U. S. ATOMIC ENERGY COMMISSION  
REGION II  
DIVISION OF COMPLIANCE

Report of Construction Inspection

CO Report No. 50-302/71-1

Licensee: Florida Power Corporation  
Crystal River Unit 3  
License No. CPPR-51  
Category A

### SKETCH - B

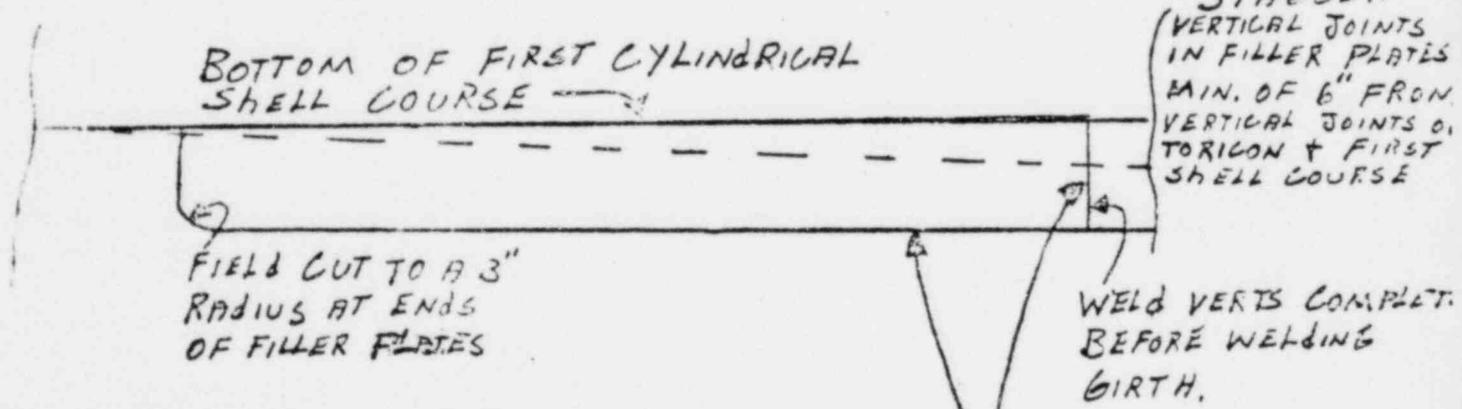
- 
1. FIT JOINT TIGHT-NO GAP
  2. ARC GOUGE BEVEL IN 1ST, SIDE + WELD,
  3. ARC GOUGE + WELD 2ND. SIDE
